## REMARKS

This is intended as a full and complete response to the Office Action dated May 4, 2004, having a shortened statutory period for response set to expire on August 4, 2004. Please reconsider the claims pending in the application for reasons discussed below.

### I. In the Drawings

Fig. 3

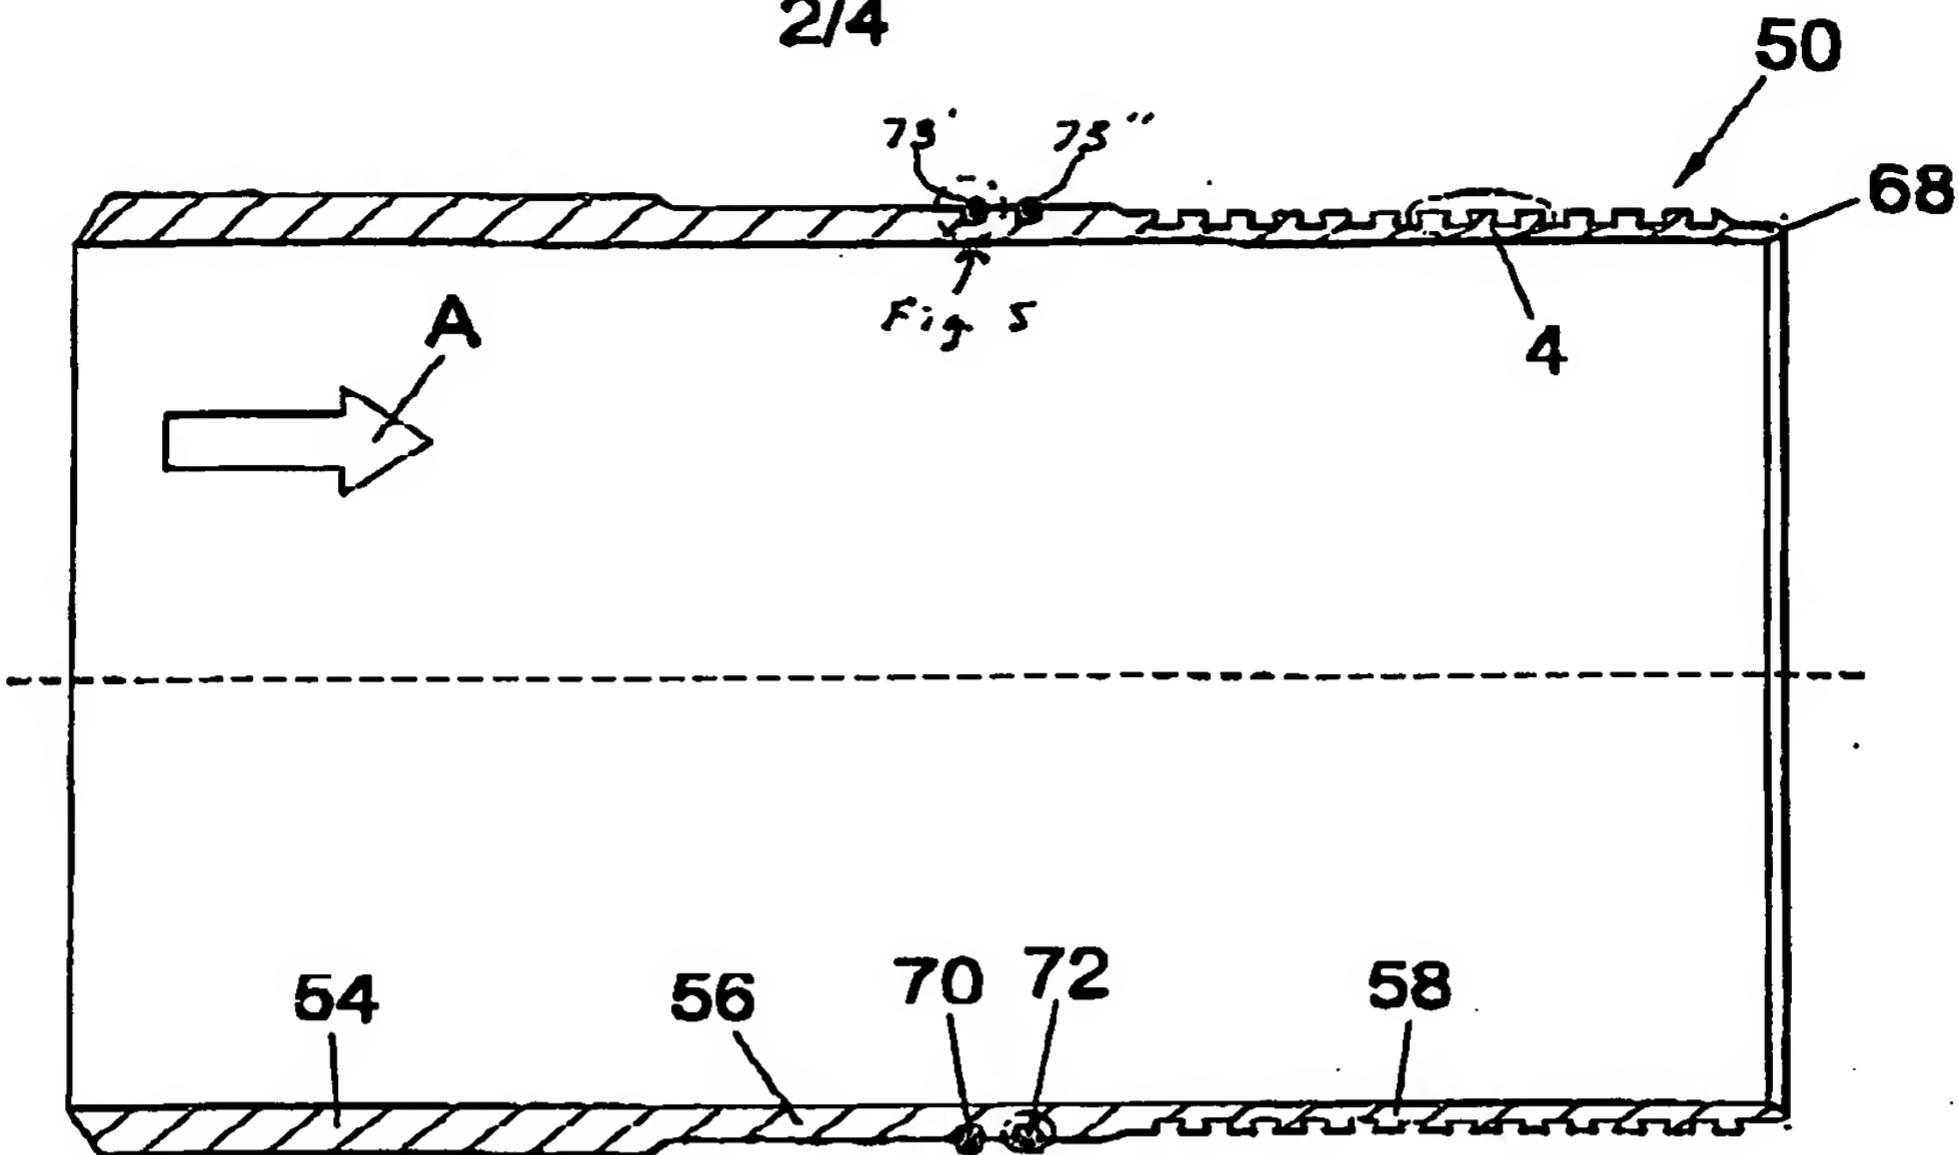
Figure 3 has been amended to include reference number 5. Reference number 5 refers to area 5 of Figure 3, shown more fully in Figure 5.

Figure 3 has also been amended to show O-rings 73' and 73". This is not new matter, as Para. [0026] of the Specification specifically mentions that O-rings may be fitted into grooves 70 and 72.

Please amend Figure 3 to include reference number 5. Reference number 5 refers to area 5 of Figure 3, shown more fully in Figure 5.

Please amend Figures 3 and 5 to show O-rings -73'- and -73"-.

Fig. 4

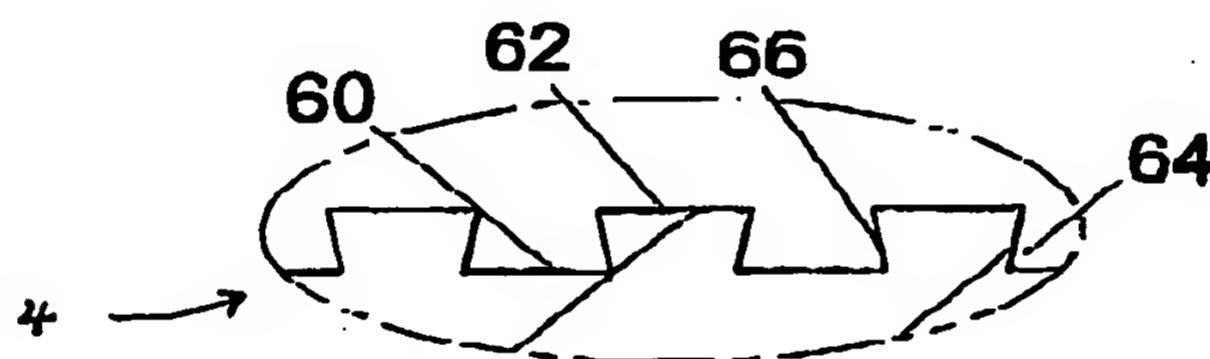
Figure 4 has been amended to include reference number 4.

Please amend Figures 4 and 5 to include reference numbers 4 and 5, respectively.

Fig. 5

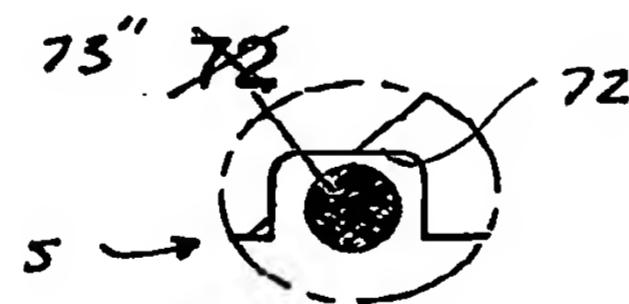
Figure 5 has been amended to include reference number 5.

Figure 5 has also been amended to show O-ring 73". This is not new matter, as Para. [0026] of the Specification describes that O-rings may be fitted into groove 72.

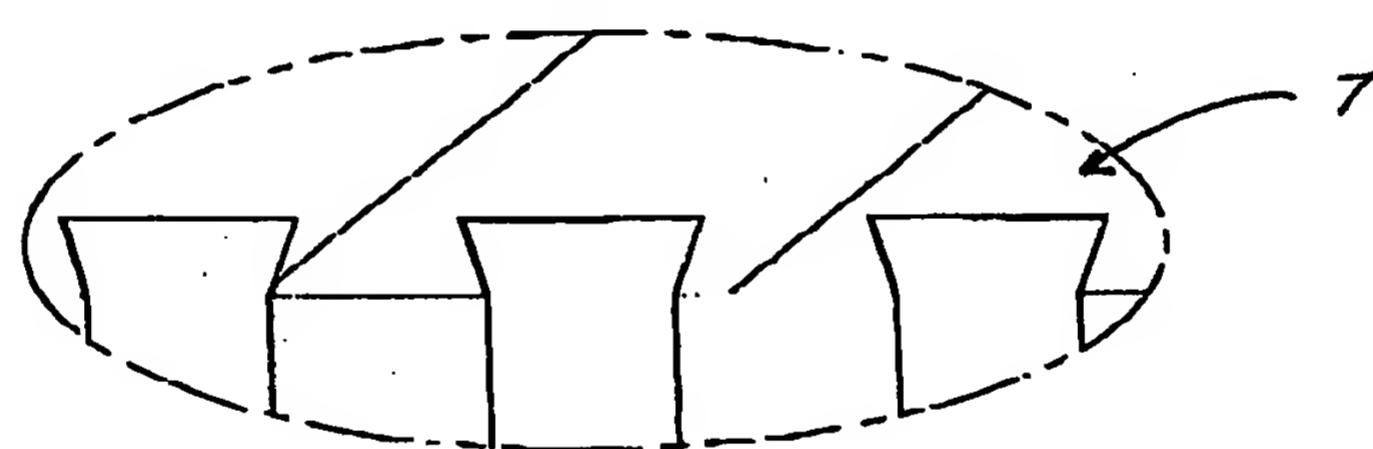
Figure 6 has been amended to include reference number 7. Reference number 7 refers to the area 7 of Figure 7. In addition, Figure 6 has been amended to include reference number 8. Reference number 8 refers to area 8 of Figure 6, shown more fully in Figure 8.

Please amend Figure 6 to include reference number -7-. Reference number 7 refers to the area 7 of Figure 7.

Please also amend Figure 6 to include reference number -8-. Reference number 8 refers to area 8 of Figure 6, shown more fully in Figure 8.

Fig. 7

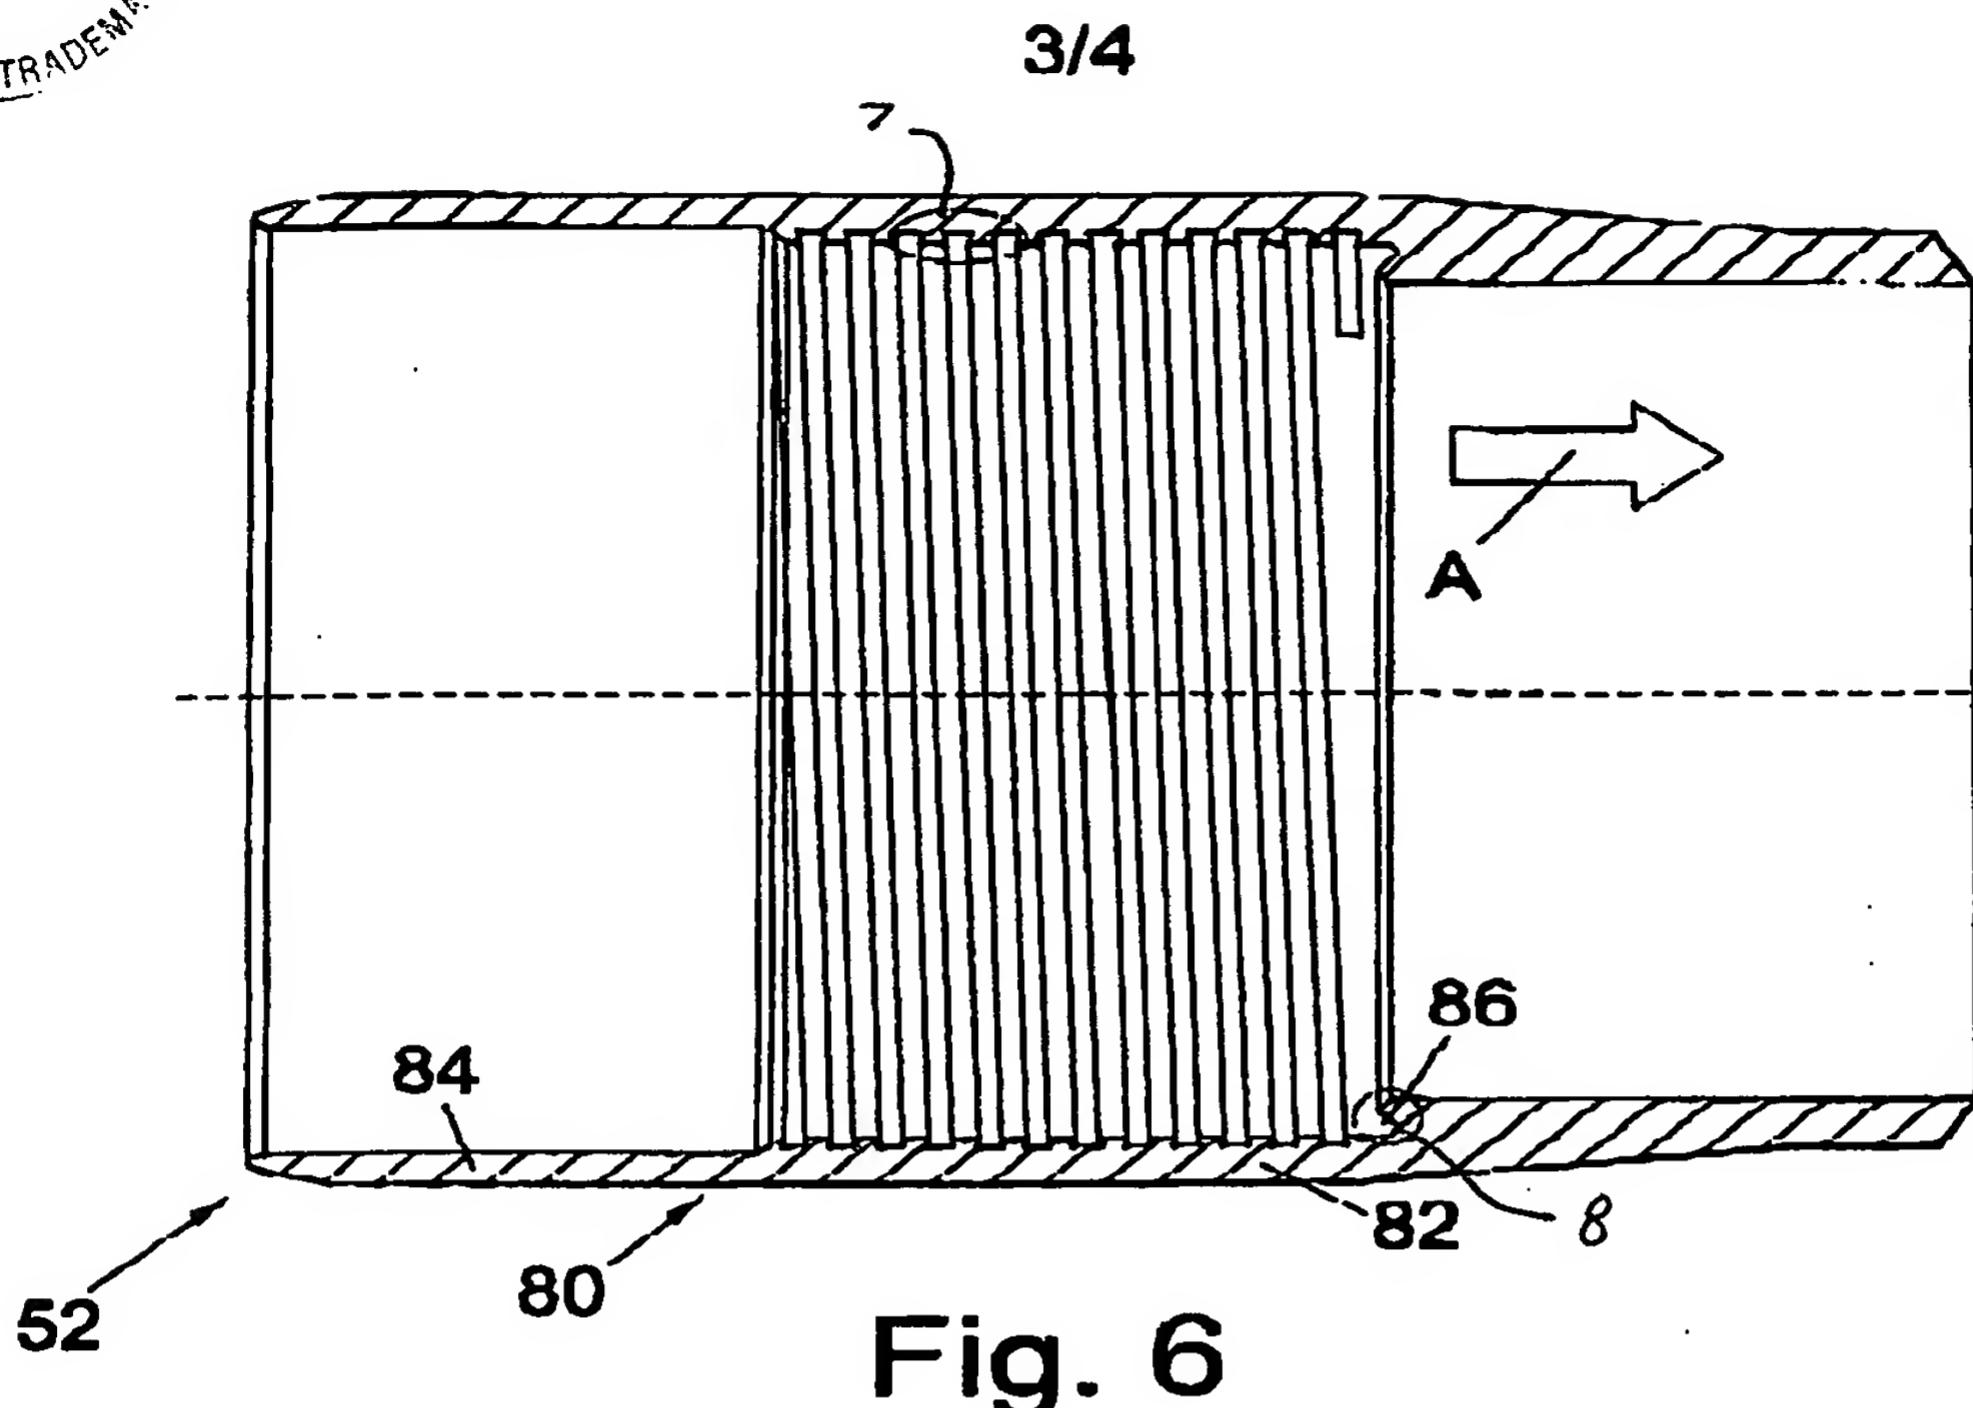
Figure 7 has been amended to include reference number 7.

Please amend Figures 7 and 8 to include reference numbers -7- and -8-, respectively.

Fig. 8

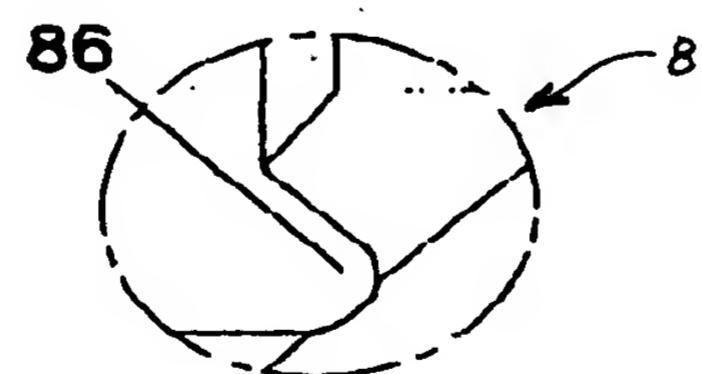
Figure 8 has been amended to include reference number 8.

**Fig. 9**

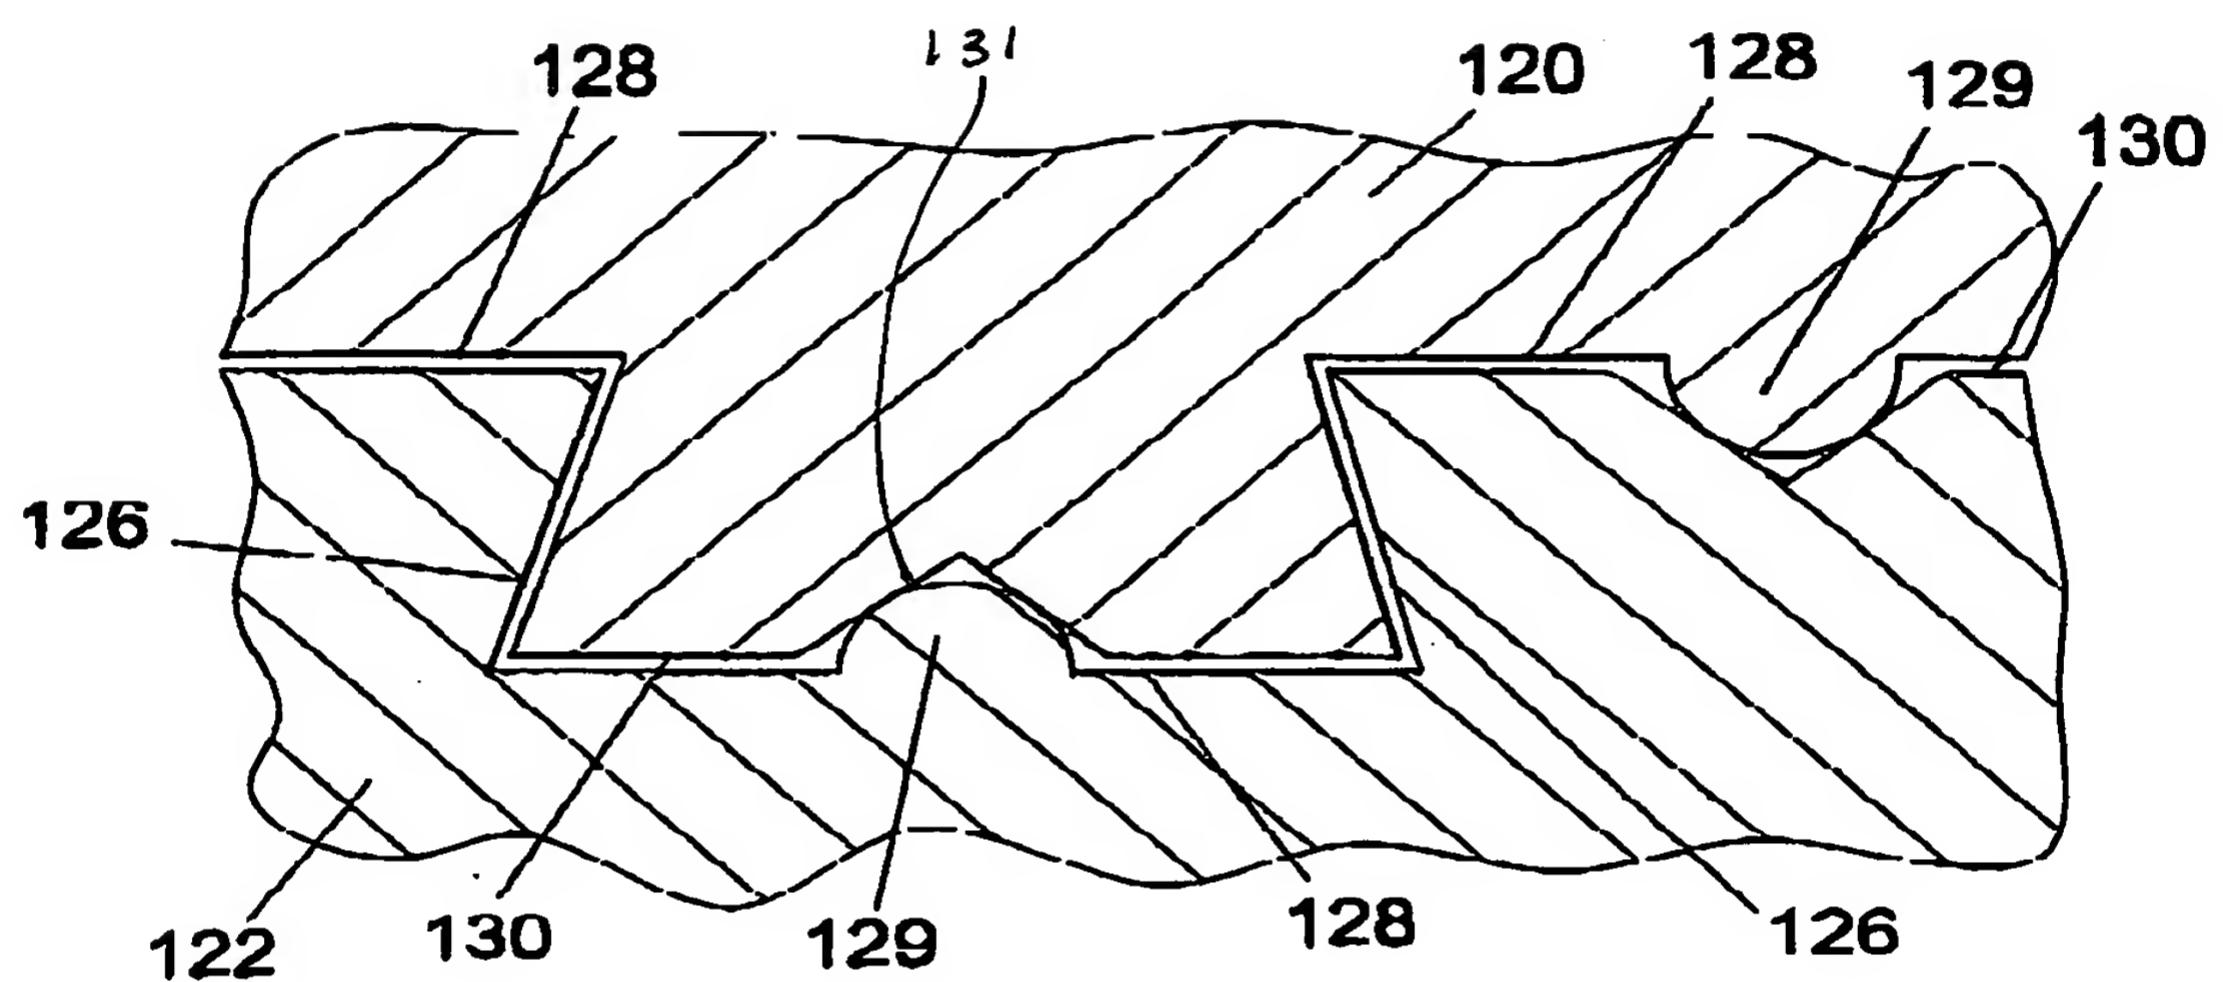
Figure 9 has been amended to include reference no. "131." This refers to the relief portion of crest 130.

Please amend Figure 9 to include reference no. -131-. This refers to the relief portion of crest 130.
